PIC24FJ256GB110 Family Silicon Errata and Data Sheet Clarification

The PIC24FJ256GB110 family devices that you have received conform functionally to the current Device Data Sheet (DS39897C), except for the anomalies described in this document.

The following typographic corrections and clarifications are to be noted for the latest version of the device data sheet (DS39897C):

FIGURE 2-3 FREQUENCY vs. ESR PERFORMANCE FOR SUGGESTED VCAP

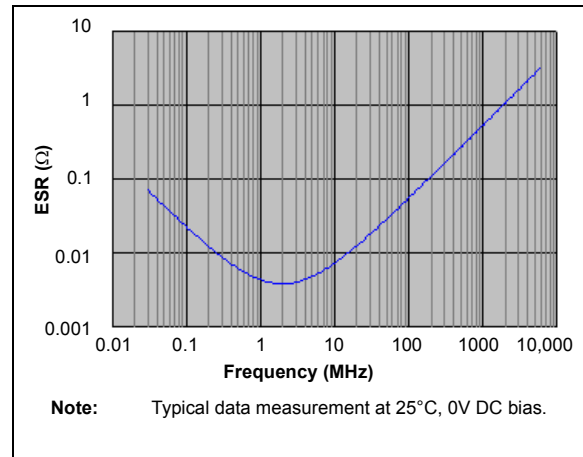
Section 2.4 Voltage Regulator Pins (ENVREG/DISVREG and VCAP/VDDCORE) has been replaced with a new and more detailed section. The entire text follows:

When the regulator is enabled, a low-ESR ($< 5\Omega$) capacitor is required on the VCAP/VDDCORE pin to stabilize the voltage regulator output voltage. The VCAP/VDDCORE pin must not be connected to VDD and must use a capacitor of 10 μF connected to ground. The type can be ceramic or tantalum. Suitable examples of capacitors are shown in [Table 2-1](#). Capacitors with equivalent specifications can be used.

Designers may use [Figure 2-3](#) to evaluate ESR equivalence of candidate devices.

FIGURE 2-4 DC BIAS VOLTAGE vs. CAPACITANCE CHARACTERISTICS

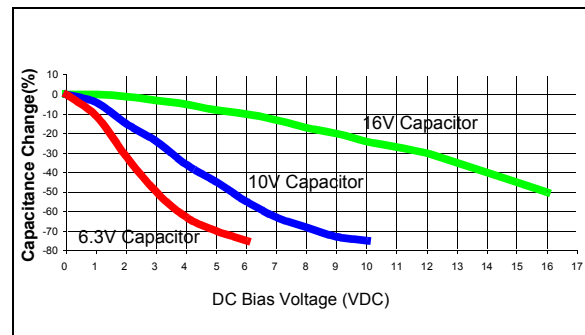
In addition to temperature tolerance, the effective capacitance of large value ceramic capacitors can vary substantially, based on the amount of DC voltage applied to the capacitor. This effect can be very significant, but is often overlooked or is not always documented.

A typical DC bias voltage vs. capacitance graph for 16V, 10V and 6.3V rated capacitors is shown in Figure 2-4.

When selecting a ceramic capacitor to be used with the internal voltage regulator, it is suggested to select a high-voltage rating, so that the operating voltage is a small percentage of the maximum rated capacitor voltage. For example, choose a ceramic capacitor rated at 16V for the 2.5V core voltage. Suggested capacitors are shown in Table 2-1.

FIGURE 29-1: PIC24FJ256GB110 FAMILY VOLTAGE-FREQUENCY GRAPH (INDUSTRIAL)

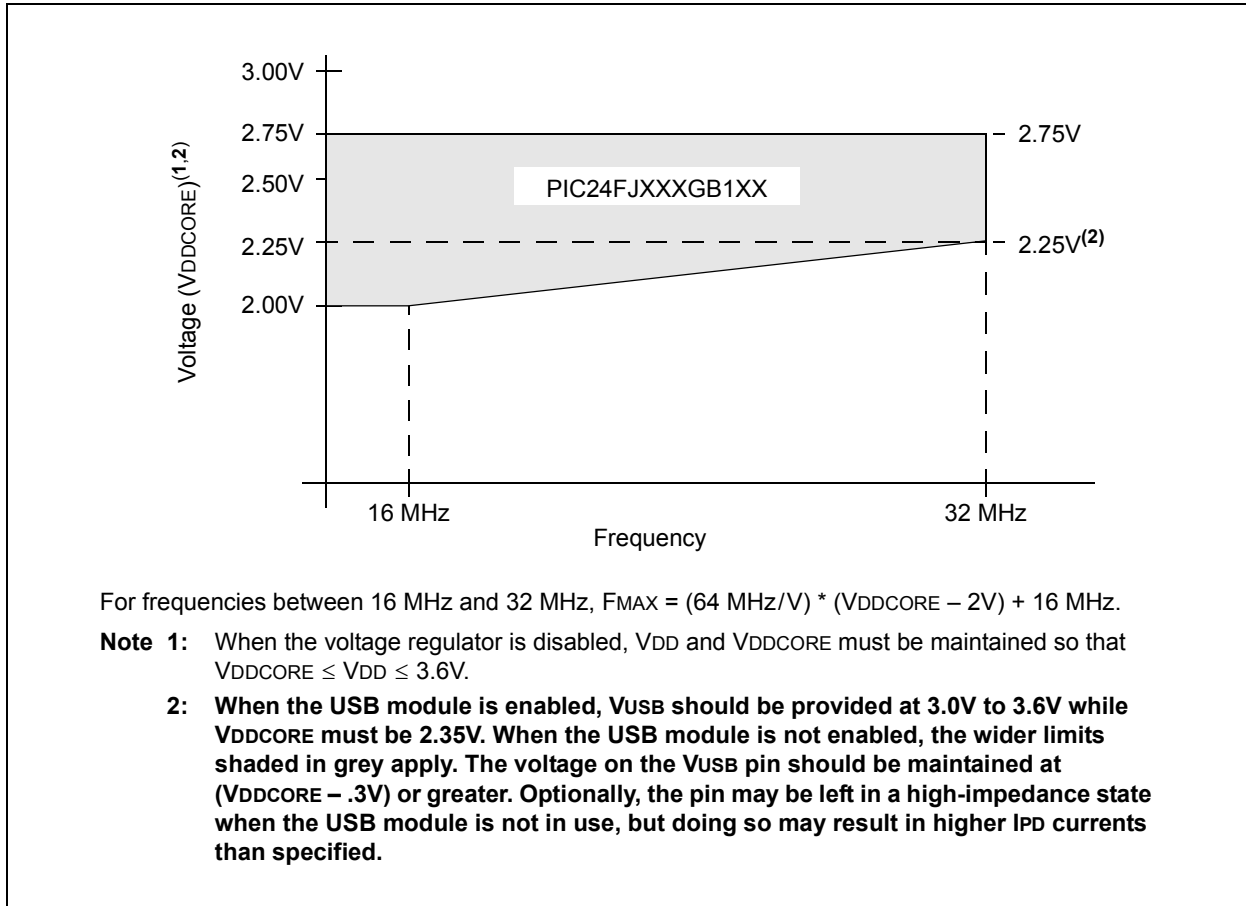
Figure 29-1 (“PIC24FJ256GB110 Family Voltage-Frequency Graph”) is amended by adding an additional footnote. The updated figure is shown below (changes in **bold**; bold in original removed for clarity).
